Vapor Intrusion Evaluation and Assessment Approach Boeing Auburn Facility Auburn, Washington

April 21, 2016

Response to Ecology Comments on the Draft Vapor Intrusion Evaluation and Assessment Approach

**RE: RESPONSE TO THE APRIL 12, 2013 WASHINGTON STATE DEPARTMENT OF ECOLOGY
COMMENTS AND REQUEST FOR REVISION OF THE DRAFT VAPOR INTRUSION
EVALUATION AND ASSESSMENT APPROACH DATED FEBRUARY 20, 2013
WAD 041337130, STATE FS ID: 2018**

Boeing Auburn Auburn, Washington	Land Use Areas and Vapor Intrusion Assessments Conducted	Figure 2
-------------------------------------	---	--------------------

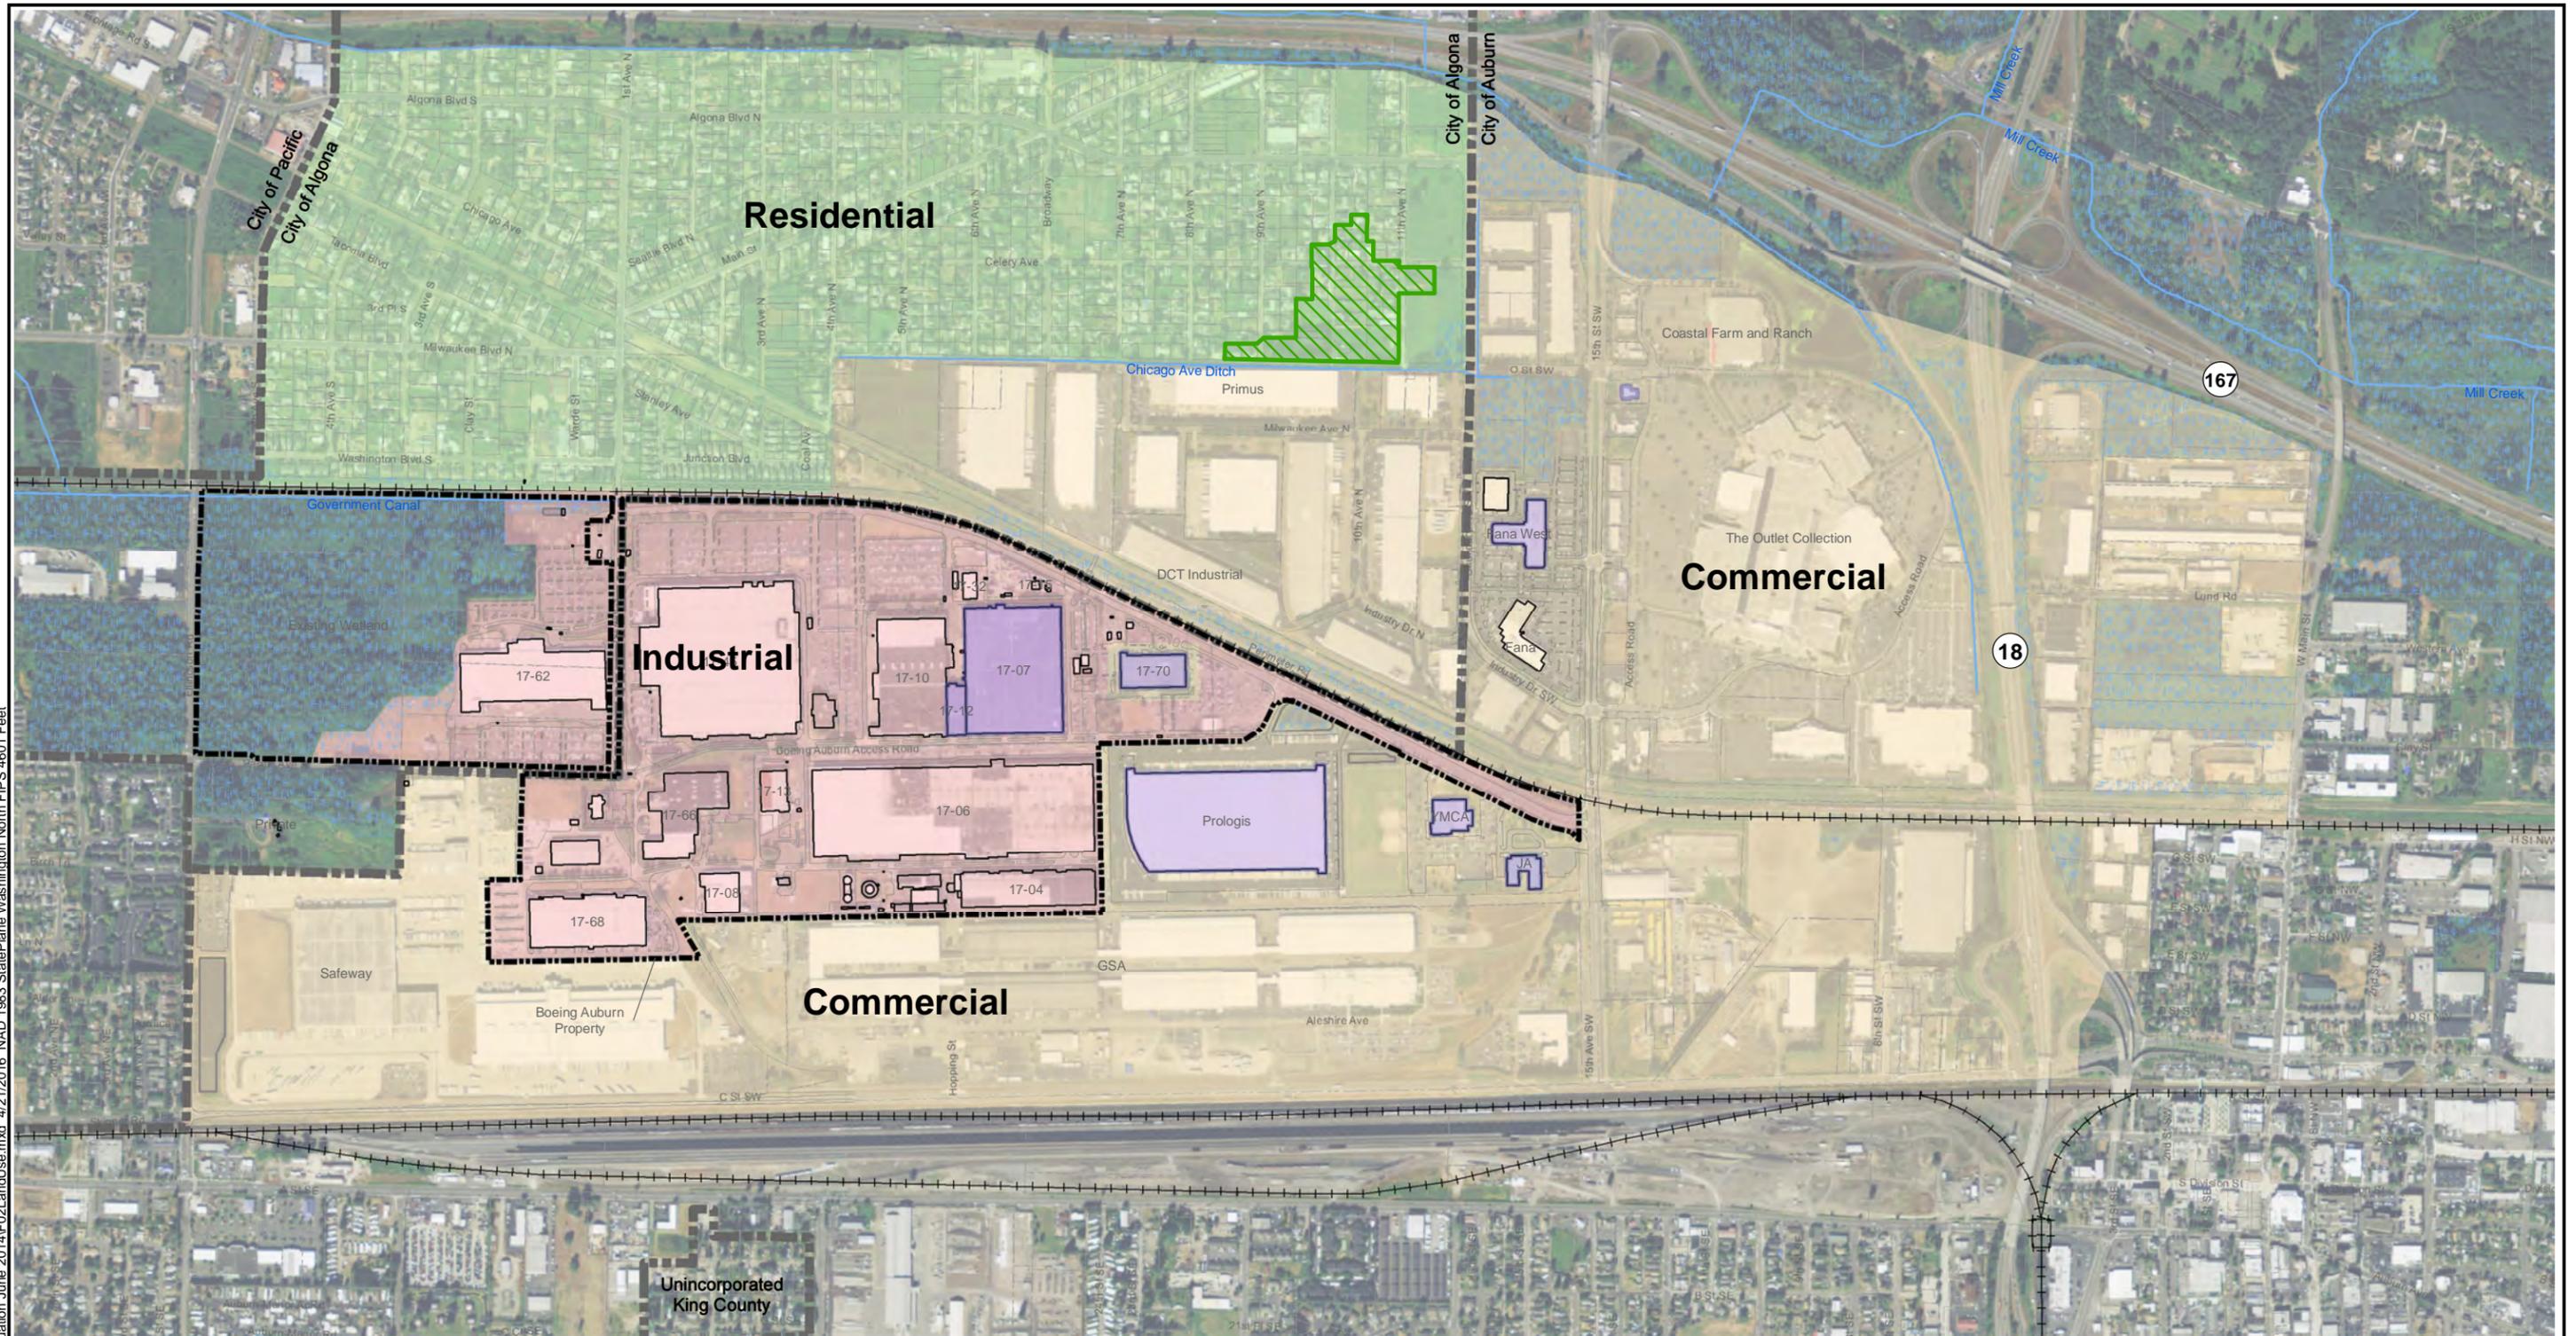
Figures 21 and 22 (and 23). It is Ecology's understanding that all the buildings located in the Industrial Land Use Area, depicted on Figure 3, are owned by Boeing. However, Ecology does not agree with Boeing that Building 17-70 meets MTCA's 'industrial' use definition:

Boeing Response to Ecology Comment 33: Comment noted. Former Figure 3 (now Figure 2) updated to show that Building 17-70 is a commercial office building. Section 3.2.3 updated to indicate that data from Building 17-70 will be screened using commercial screening criteria rather than industrial. Note added to figure explaining that some buildings within the industrial area may be for commercial use.

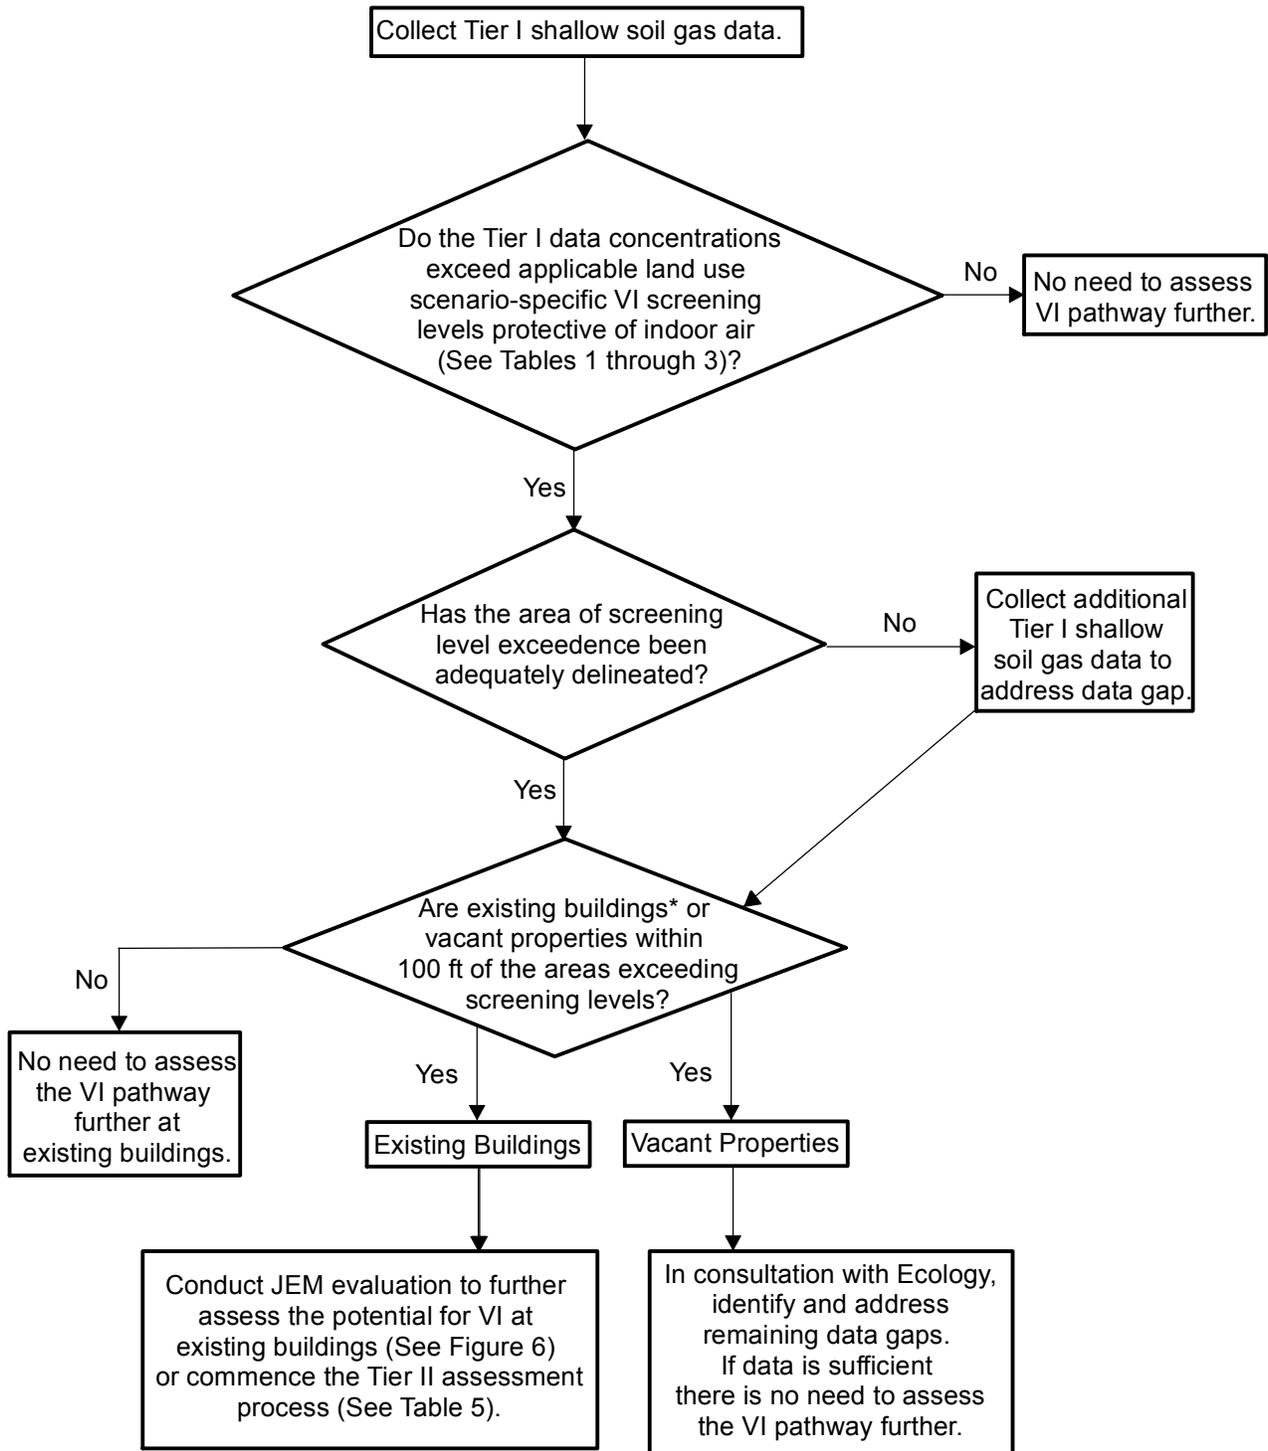
Figures 6 and 8. Question: how does "no existing building" differ from "vacant property"?

Figures 6, 7, and 8. As noted in comments above, there are certain building/foundation features that, if present, can cause questions to arise about the conservativeness of the proposed subsurface screening levels. The figures do not state how Boeing will determine if the buildings above the plume have any of

Boeing Response to Ecology Comment 23: Former figures 6 and 8 (now figures 5 and 7) have been updated to more clearly address vapor intrusion assessment off ramps.

Boeing Response to Ecology Comment 24: A brief note has been added to former Figures 6 and 8 (now Figures 5 and 7). Former Figure 7 (now Figure 6) has been revised, as addressed below under comment #25.

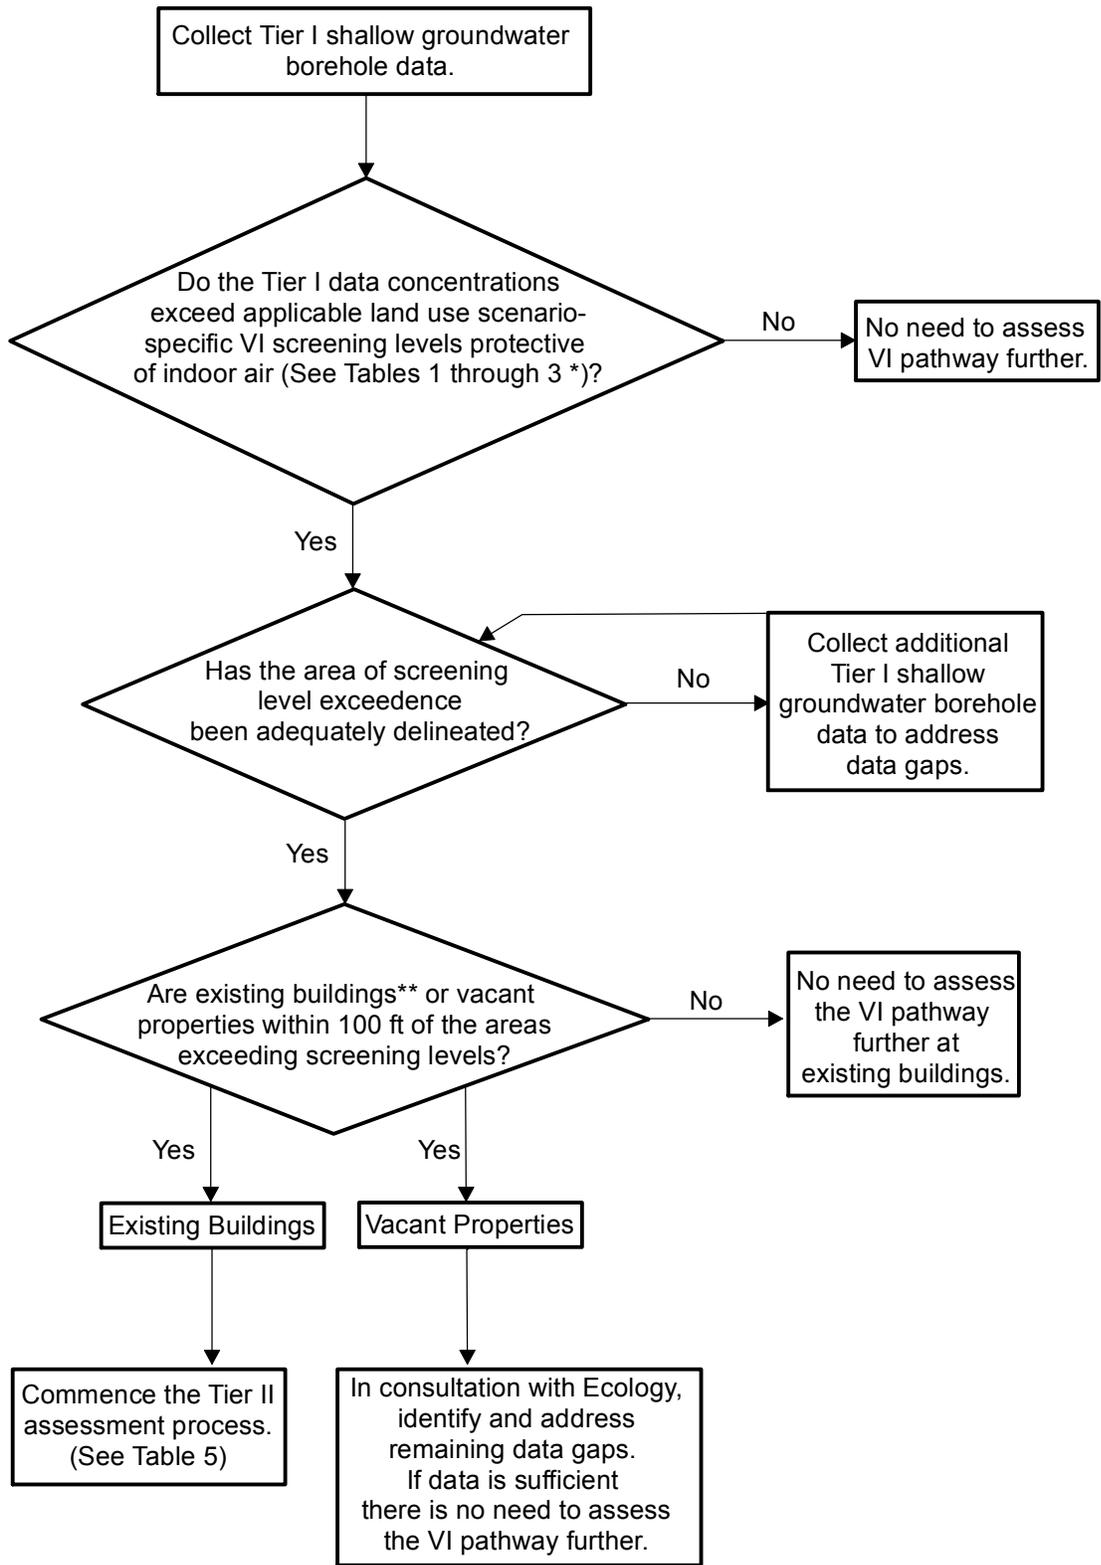
Figure 8. The flowchart states that if shallow groundwater concentrations are below the proposed SLs, there is no need for further VI assessment of buildings in the immediate area. Ecology disagrees that the proposed groundwater SLs can be used by themselves to reach such a conclusion. Please see our comments above and in the cover letter.

Boeing Auburn Auburn, Washington	Commercial Auburn Additional Vapor Intrusion Assessment Area	Figure 16
-------------------------------------	---	---------------------

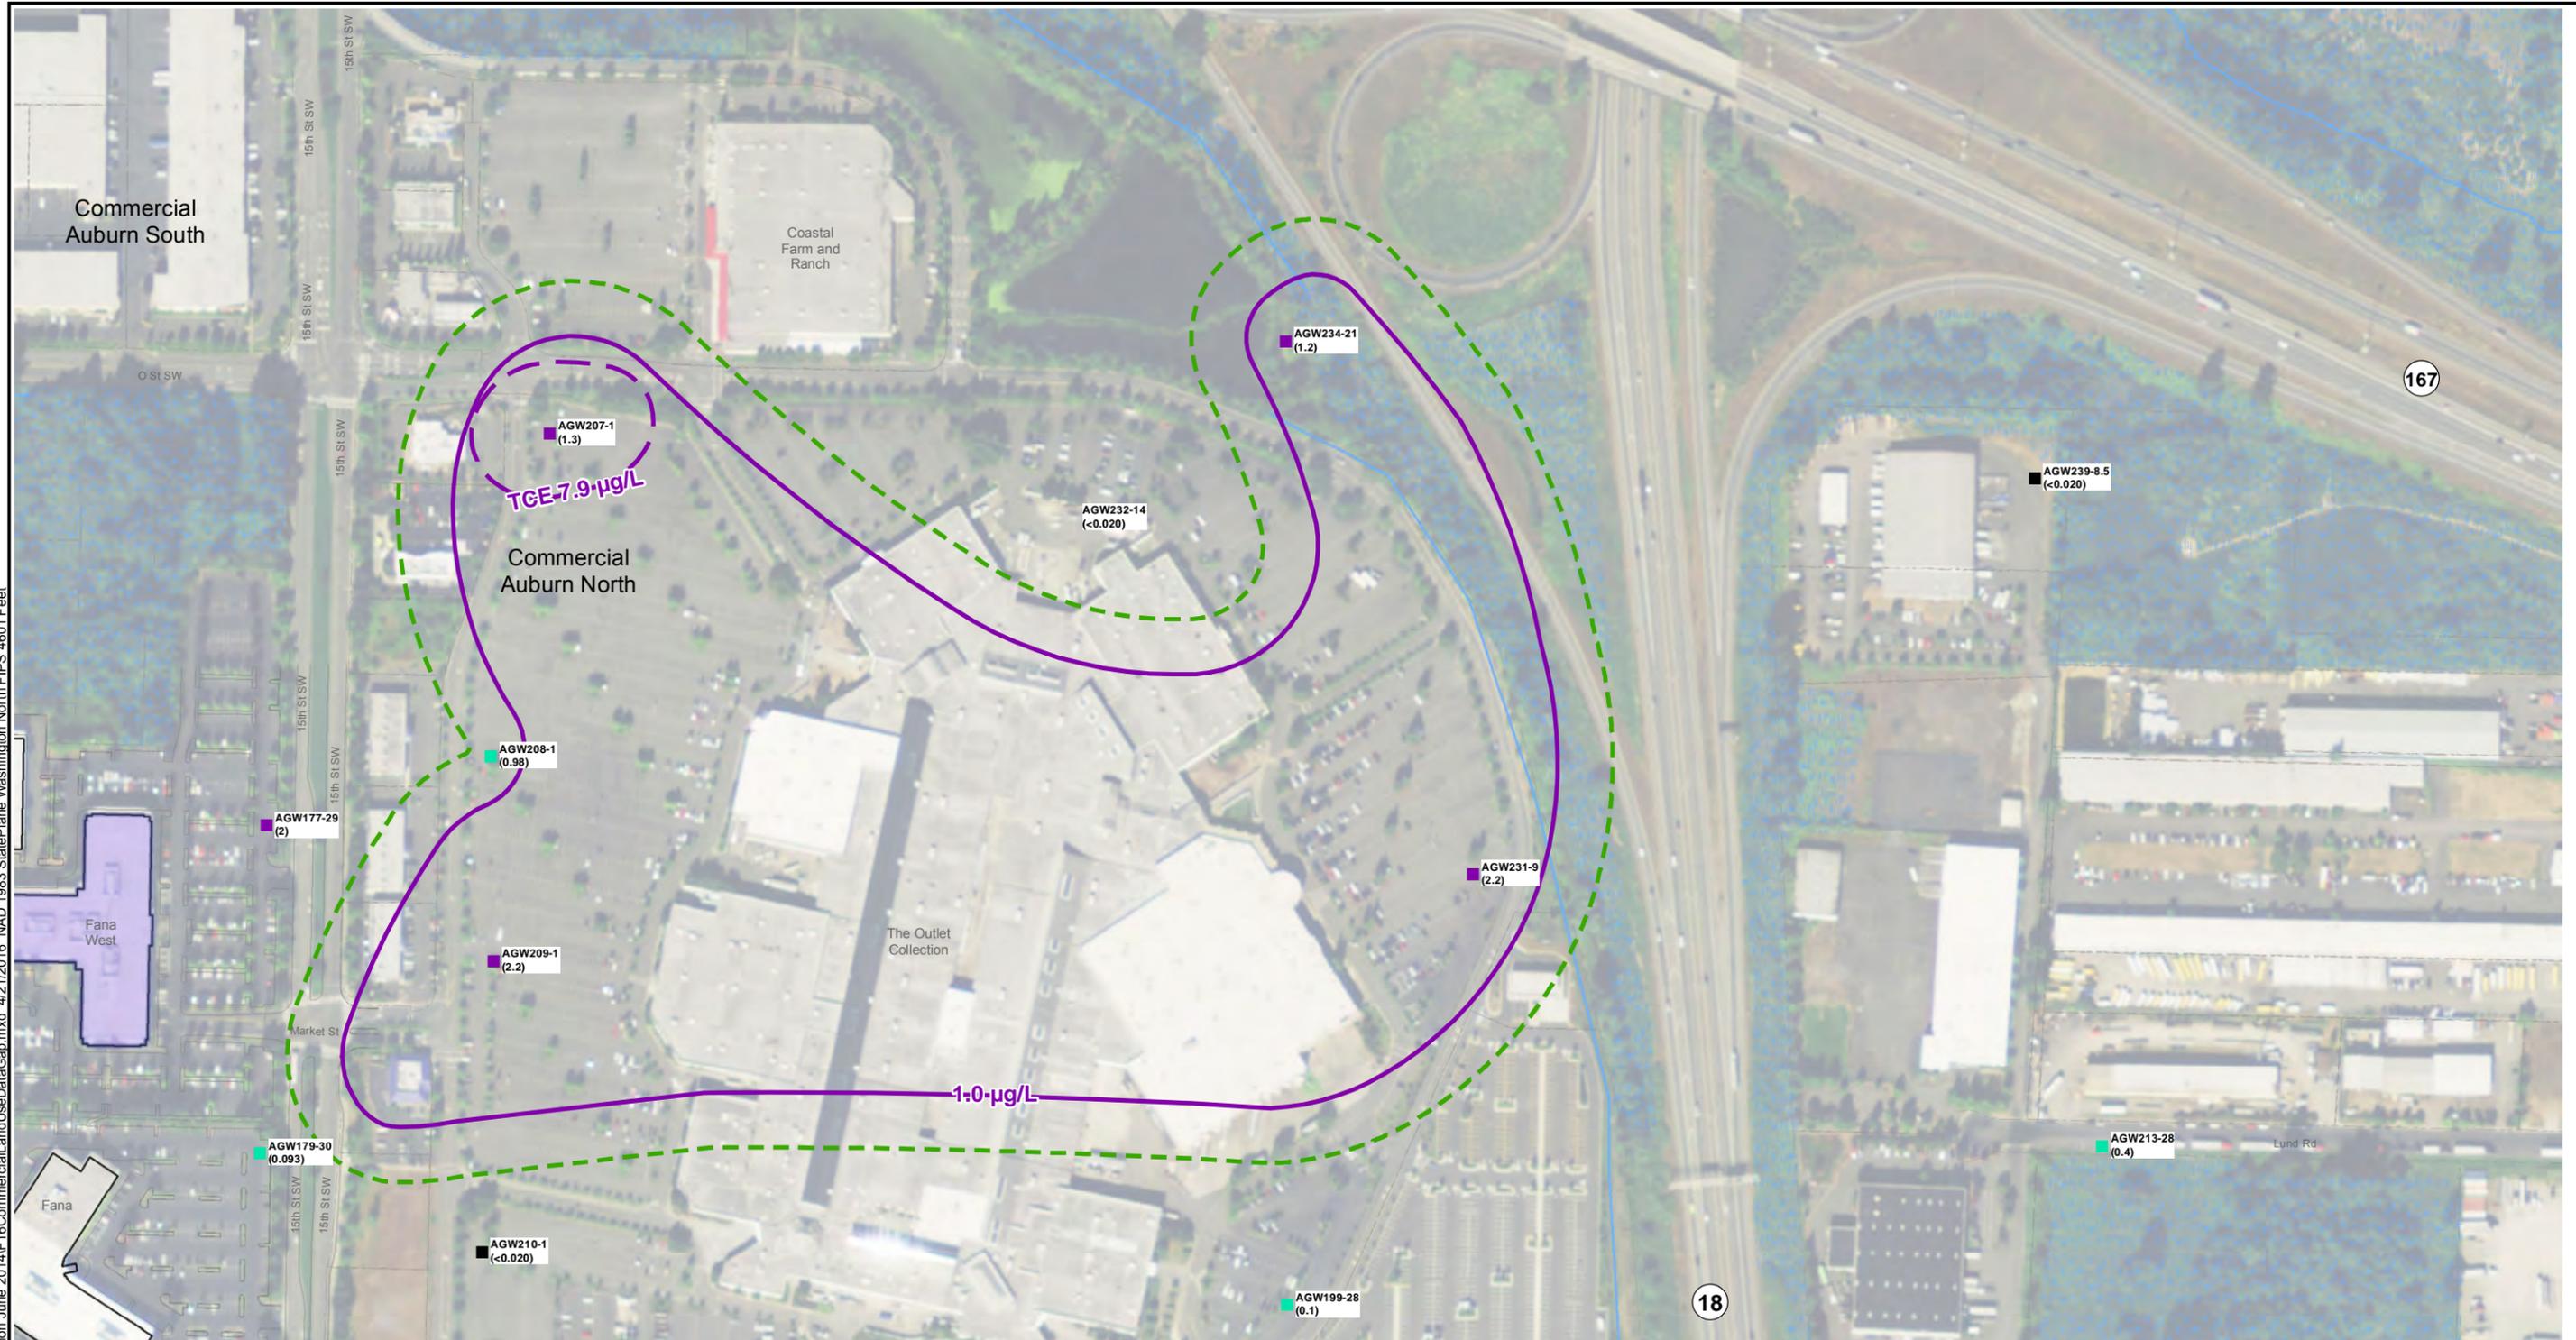
Figure 14. The figure would be improved by contouring concentrations associated with the residential (0.35 ug/l) and commercial (1 ug/l) groundwater SLs for vinyl chloride.

Boeing Response to Ecology Comment 30: Comment noted. We provide the residential and commercial land use scenario specific VC contour figures later in the document (current figures 13 and 16, respectively).
